**ADDENDUM #1**

**DATE:** June 2, 2026  
**PROJECT:** Terrebonne Parish Consolidated Government  
Dulac Pontoon Bridge Drydock Project  
Parish Project No. 25-BRG-07  
**TO:** PROSPECTIVE BIDDERS

NOTES & QUANTITIES	
TERREBONNE PARISH CONSOLIDATED GOVERNMENT DULAC PONTOON BRIDGE DRYDOCKING PROJECT PARISH PROJECT NO. 25-BRG-07	
DULAC, LOUISIANA	TERREBONNE PARISH

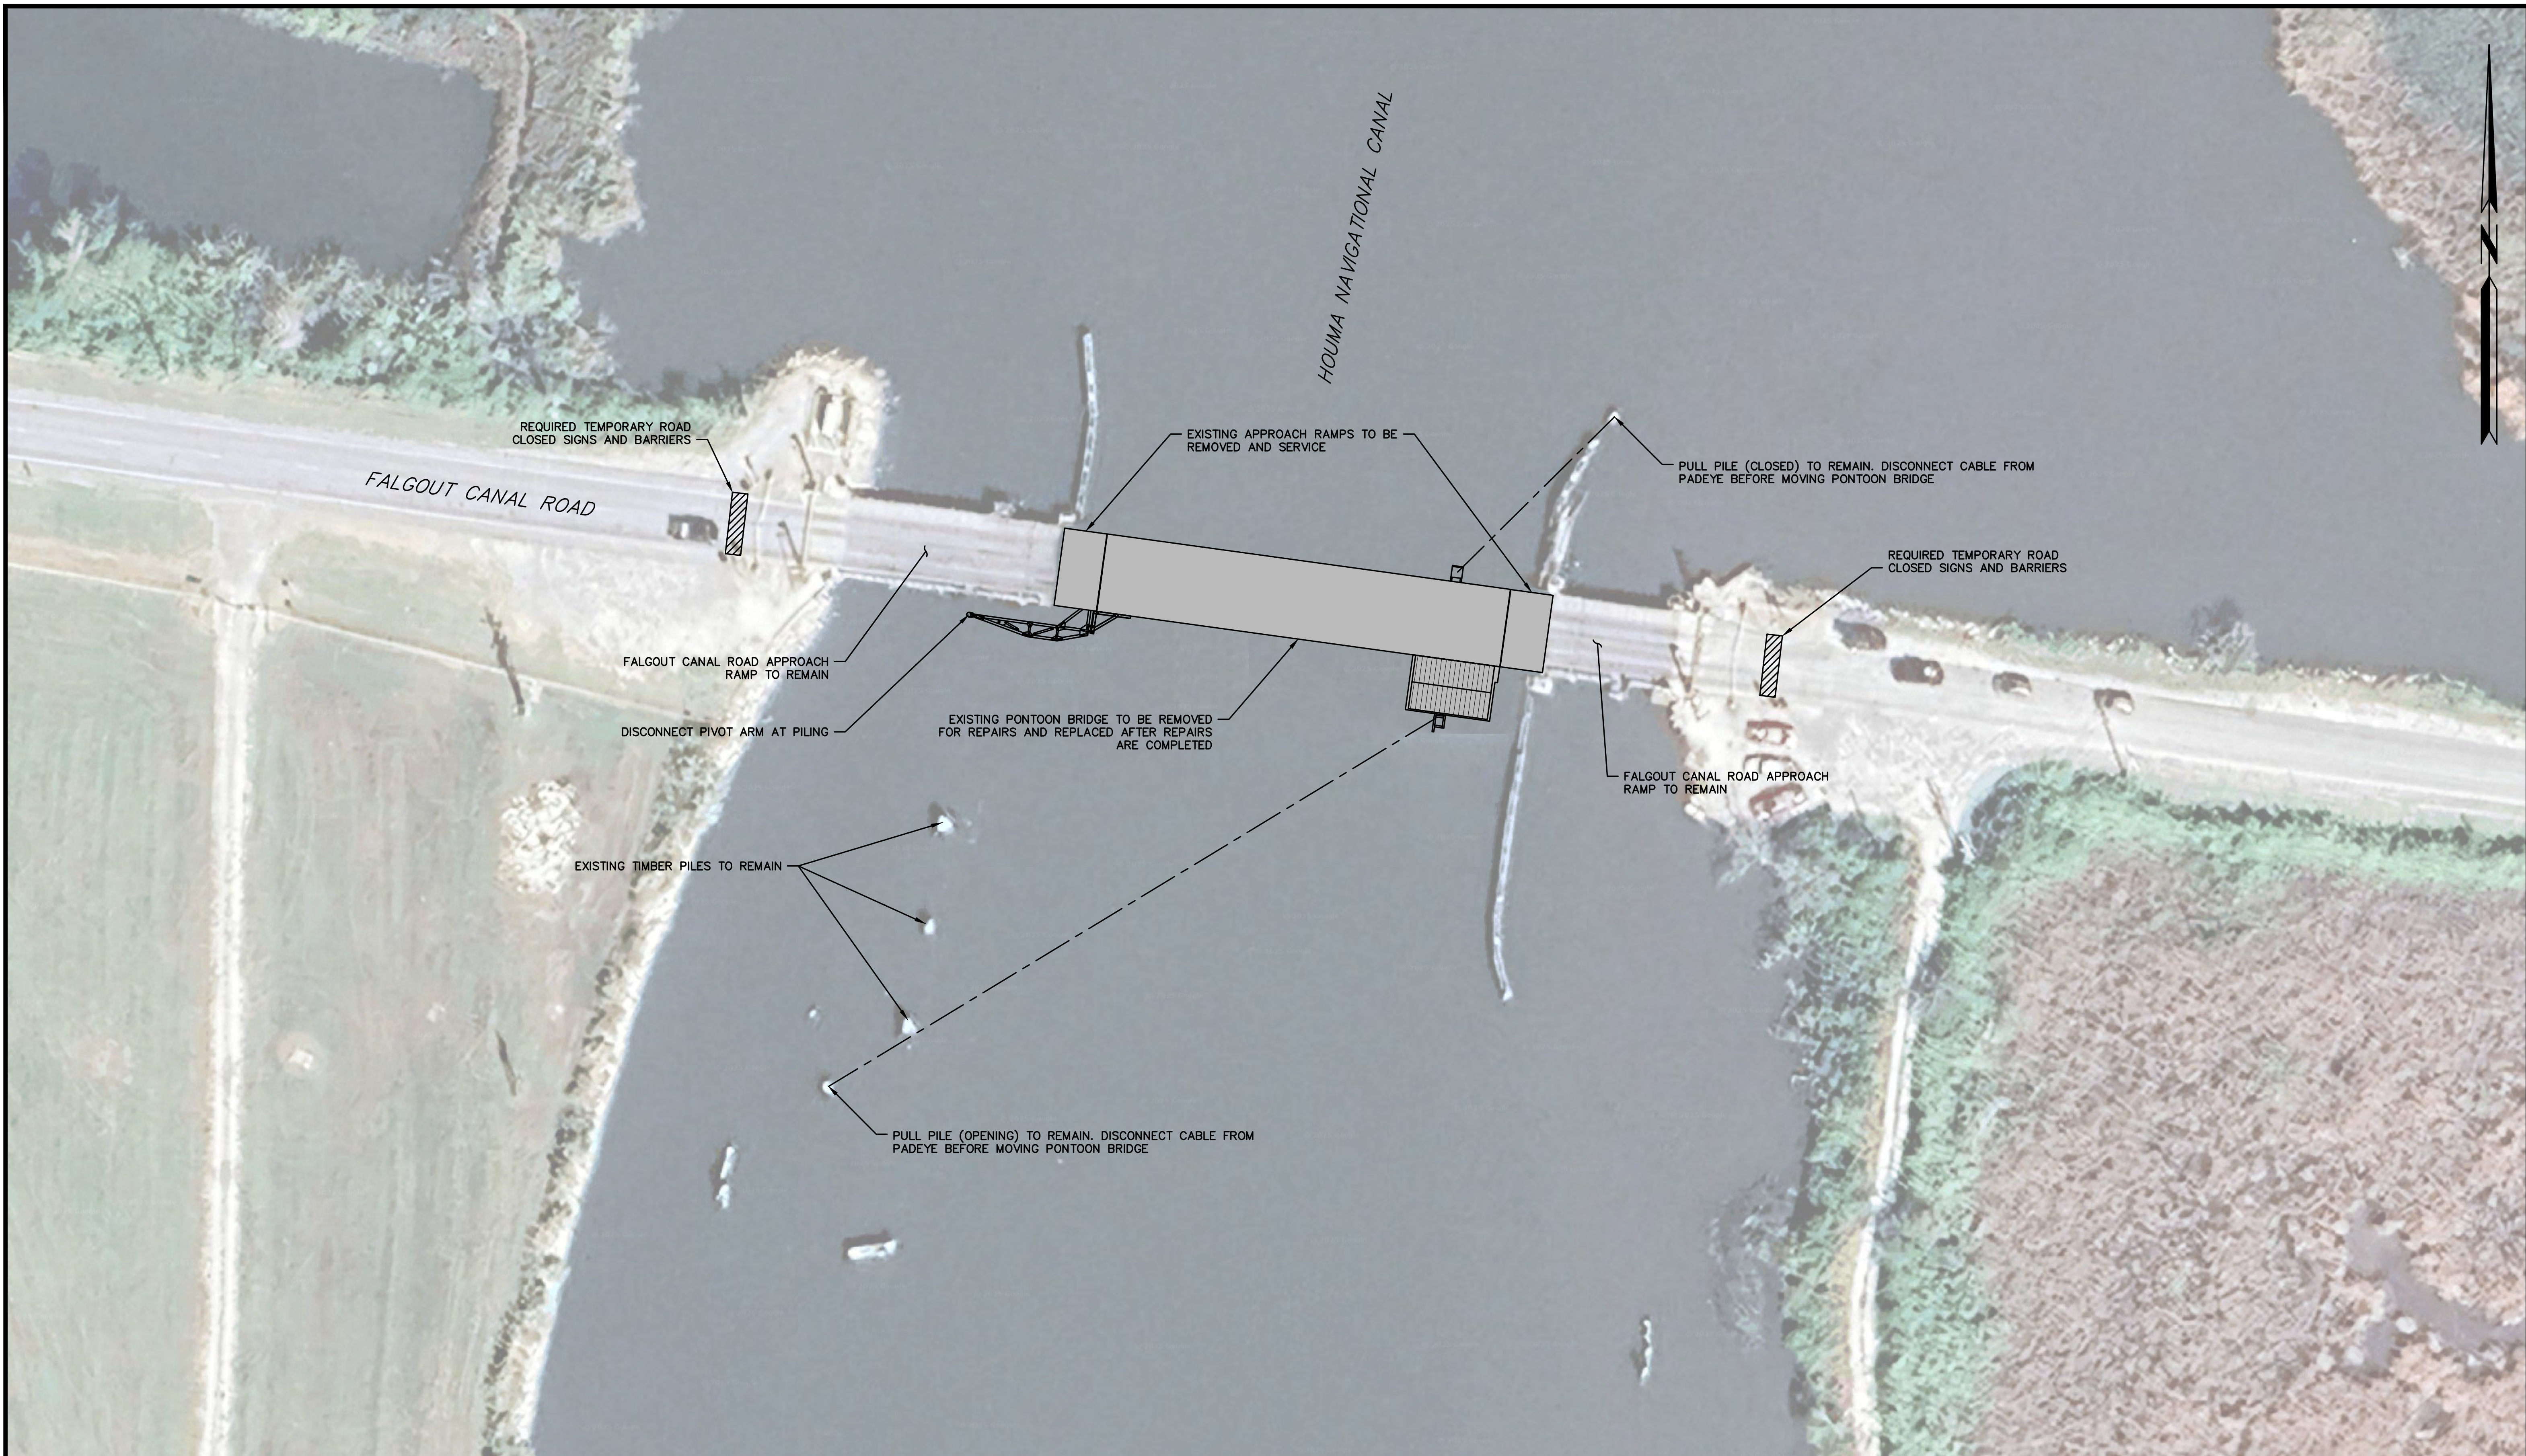
- DISCONNECTING, RECONNECTING, AND TRANSPORTING THE DULAC PONTOON BRIDGE.
- DRY-DOCKING, INSPECTING, AND REFINISHING THE DULAC PONTOON BRIDGE.
- SERVICING ALL MECHANICAL EQUIPMENT. (ADDITIVE ALTERNATE NO. 1)
- ~~SERVICING PIVOT ARM AND~~ PIVOT PILE. (ADDITIVE ALTERNATE NO. 2)

14. THE CONTRACTOR SHALL DISASSEMBLE THE EXISTING PIVOT ARM, INSPECT AND REPACK THE HOUSING, AND RE-ASSEMBLE THE PIVOT ARM. THE CONTRACTOR SHALL ALSO BE REQUIRED TO SUPPLY ALL NEW STAINLESS-STEEL BOLTS LOCATED ON THE PIVOT ARM INCLUDING NEW BOLTS ON THE SLEEVE THAT CONNECTS TO THE PIVOT PILE.

ALTERNATE NO. 2			
ITEM NO.	DESCRIPTION	UNIT	QUANTITY
<del>B.001</del>	<del>SERVICE PIVOT ARM</del>	<del>LUMP SUM</del>	<del>1</del>
B.001	RESURFACING AND INSPECTION OF PIVOT PILE	LUMP SUM	1

A: Resurfacing of Pivot should be completed in the Service Pivot Arm Item. This item was revised to the Basebid in the Addendum No.1. All work on the Pivot Pile shall remain as an Additive Alternate.

SCALE SHOWN	<b>PIVOT ARM</b>
DATE 3/5/2026	
PROJECT 2025.026	
FIELD BOOK	
DULAC, LOUISIANA	TERREBONNE PARISH

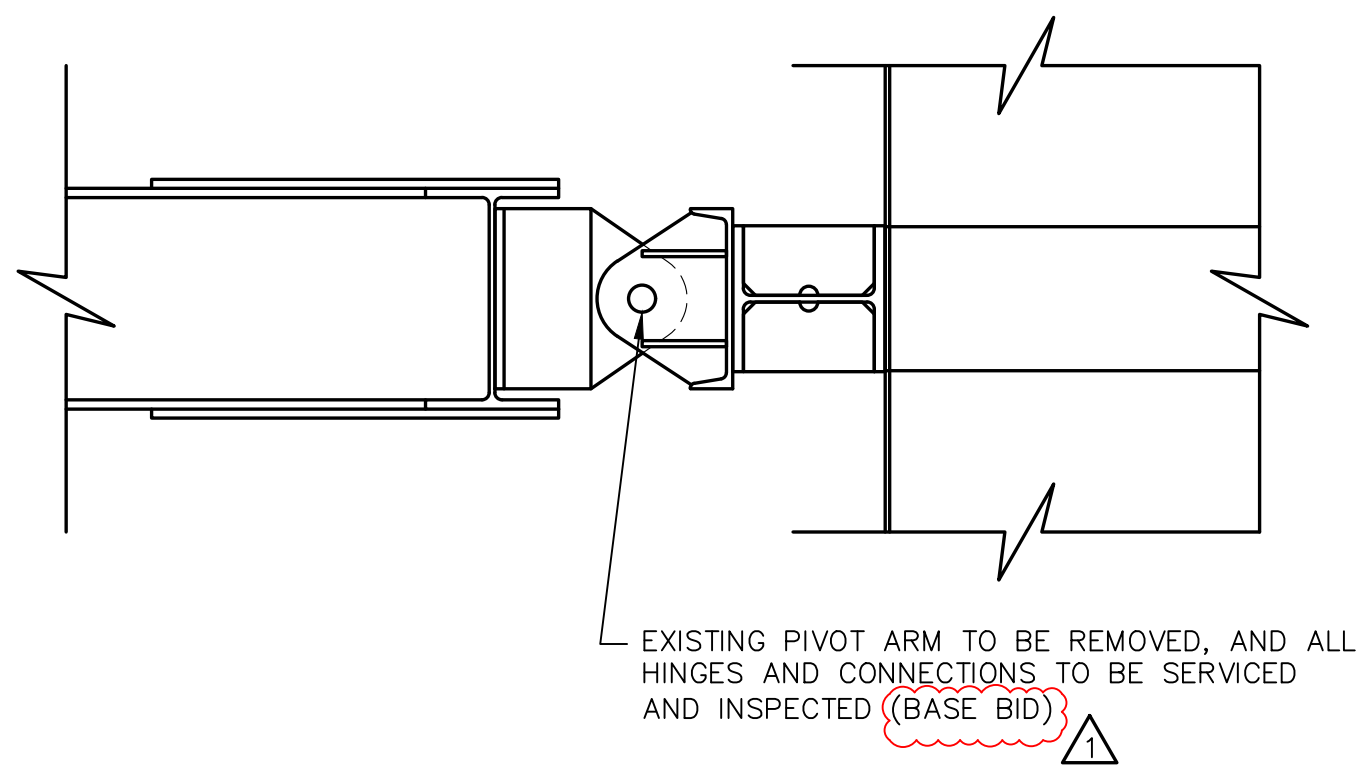
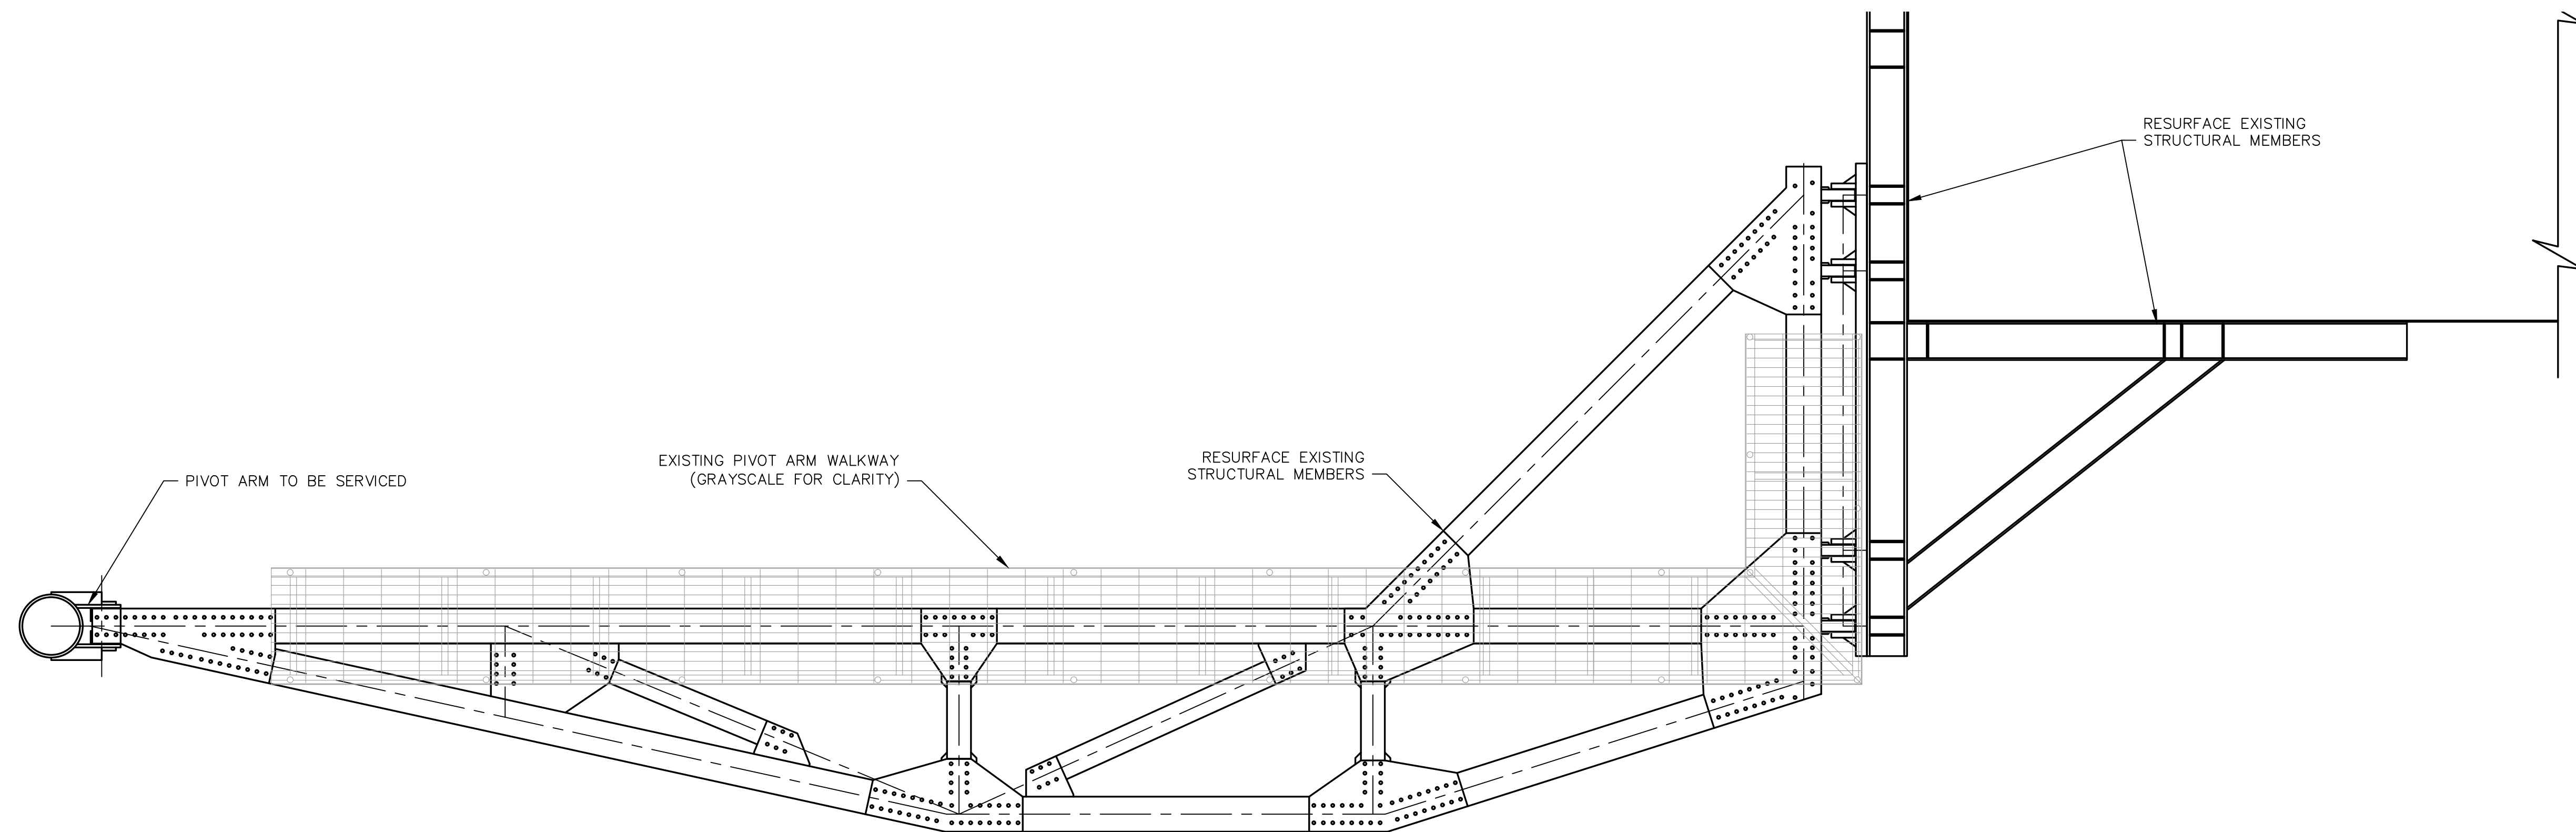
7. Q: Should pivot arm re-surfacing be included in B.001-Service Pivot Arm? Conflicting notes in plans/specs.

APRON ELEVATION  
SCALE: 3/4" = 1'-0"

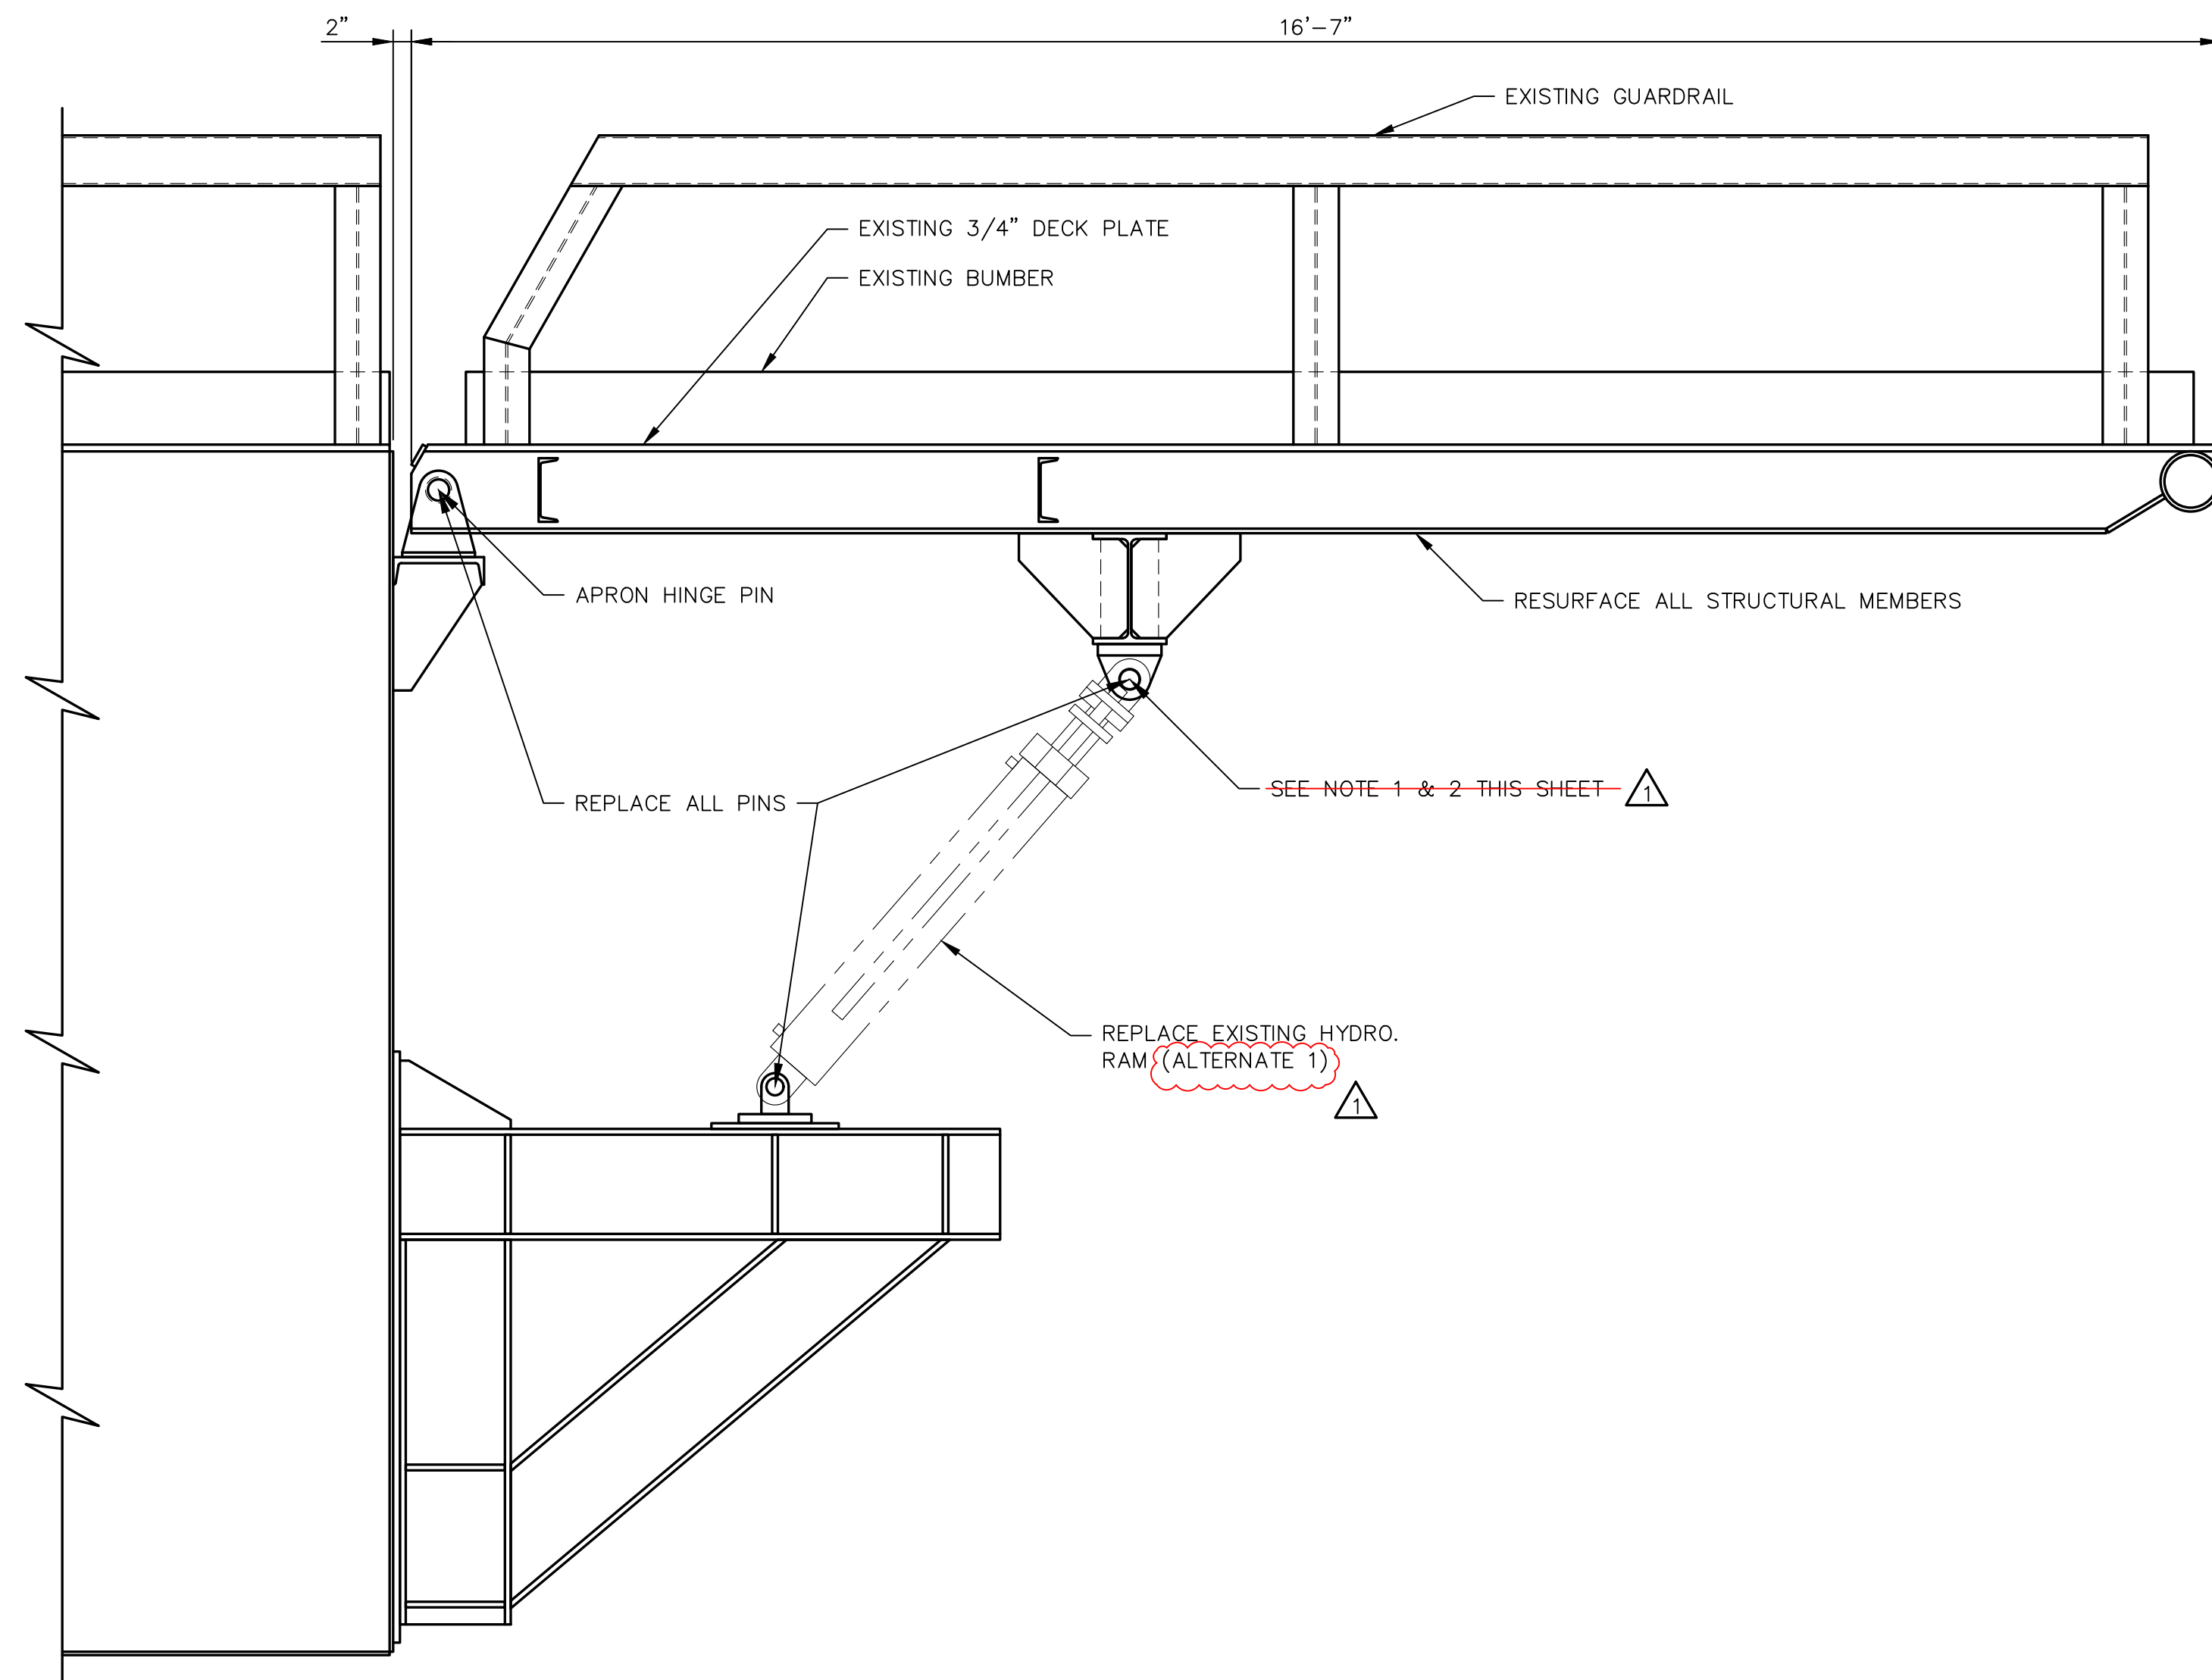
6. Q: Should all apron & hydraulic ram pins be replaced or inspected? Conflicting notes on plans.

- NOTES:
1. THE CONTRACTOR SHALL REPLACE ALL APRON HINGE PINS AND HYDRAULIC RAMS. THE CONTRACTOR SHALL DELIVER OLD RAMS AND PINS TO THE OWNER ONCE REMOVED.
  2. THE CONTRACTOR SHALL INSTALL NEW GREASE FITTINGS ON THE APRON HINGE HOUSINGS TO ENSURE THAT HINGES CAN BE PROPERLY LUBRICATED.

A: Apron and Hydraulic Pins should be inspected and damages need to be reported to Engineer and Owner.
